PLANNING APPLICATION REF. 17/00353/PPPL

DESCRIPTION OF DEVELOPMENT: PROPOSED NEW HOUSE PLOT - RE-APPLICATION

LAND AT OLD MANSE RESCOBIE FORFAR

REPRESENTATIONS

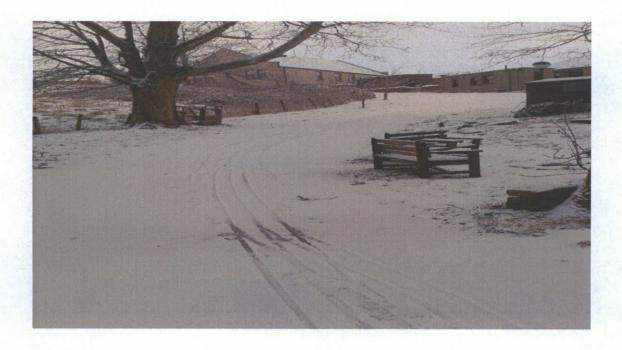
As you can see If I were leaving my property at the same time as another vehicle coming up the track or out of the new access point we would without doubt collide.

The next two photo's give you an indication of the steepness of the drive and the problems another access point / additional traffic could create.

The second issue with access

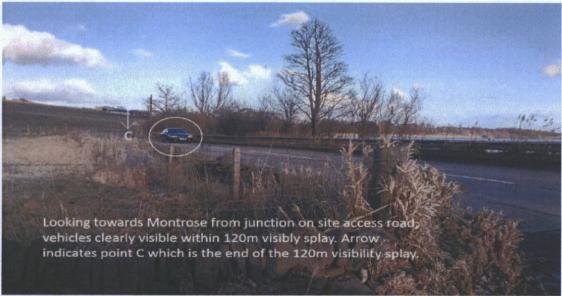
The Existing Access Conditions Report gives an overview on the existing access to and from the junction and to a layman like myself it seems to cover the main points. However I can only speak for personal experience and I would like to state the following:
